AMENDMENTS TO THE DRAWINGS:

REMARKS

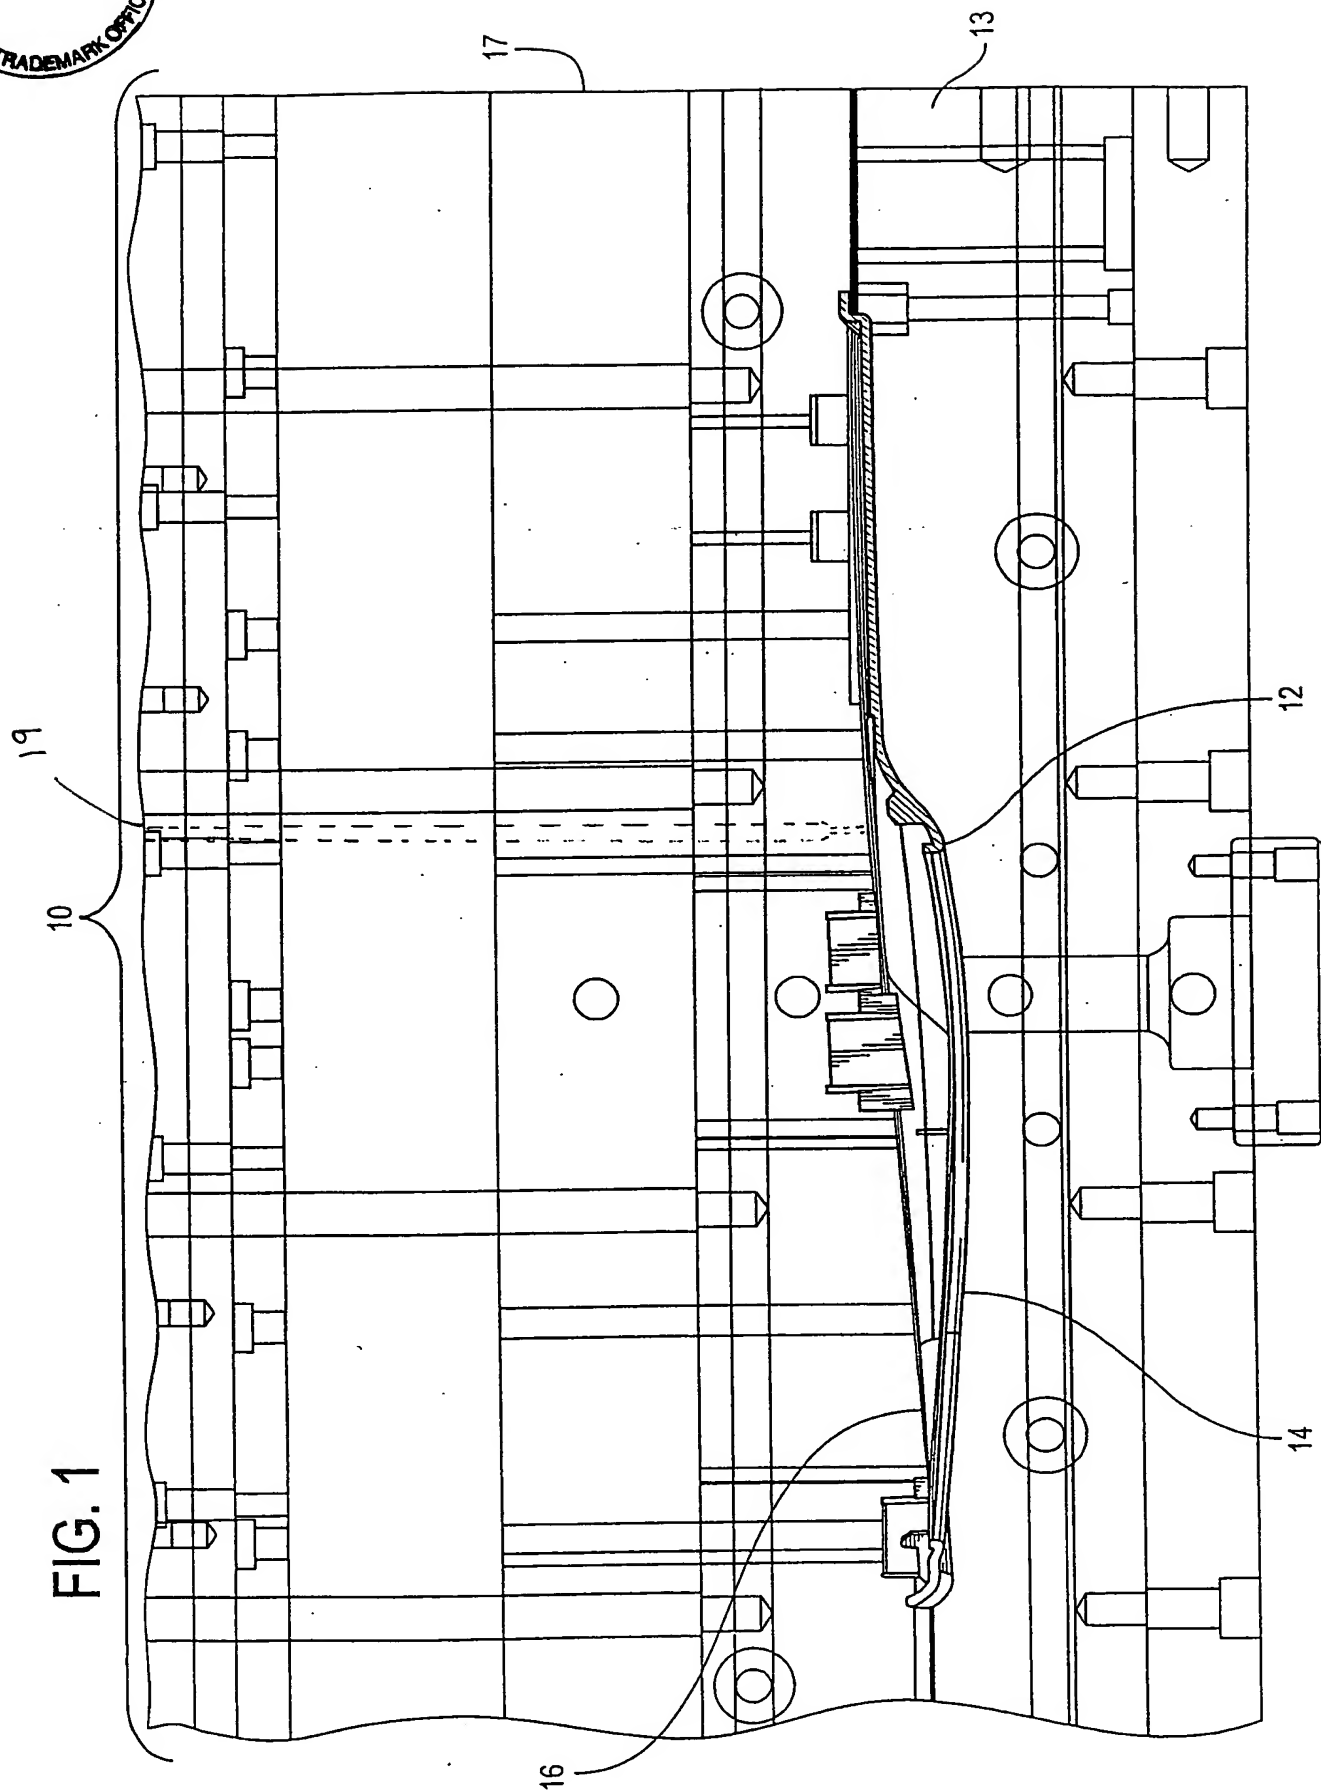
- Figure 1 is amended to add an injection port and reference numeral 19 which is identified in the specification at page 10, line 2. Injection port 19 is also present in Figures 6-9, 11A, 12A and 13A.
- Figure 13A is amended to include reference numeral 78 which is described in the specification at page 17 line 21.
- Figures 11B, 11C, 14A and 14B are amended to distinguish the resulting trim piece features from features 68 associated with the mold used to manufacture the trim level pieces.

- Figure 1 is amended to include an injection port and numerical designation 19. Injection port 19 is also present in Figures 6-9, 11A, 12A and 13A.
- Figure 13A is amended to include missing feature 78.
- Figures 11B and 11C are amended to identify the resin feature using numeral 76 instead

FIG. 11B

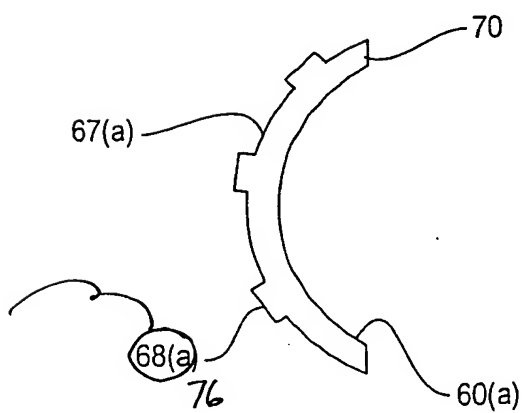
of numeral 68(a).

FIG. 14A

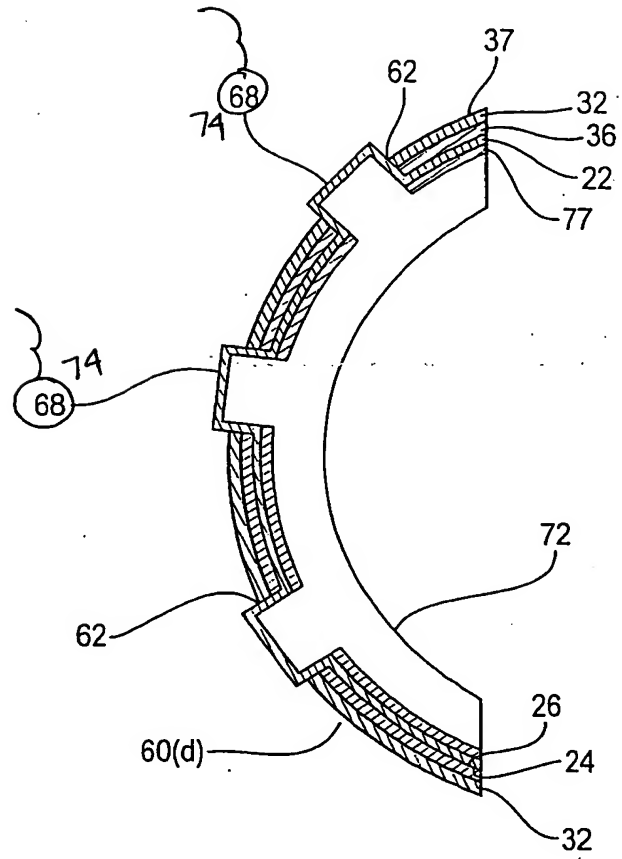
- Figures 14A and 14B are amended to identify the trim level piece features as preformed skin covered feature 74 as disclosed in the specification.
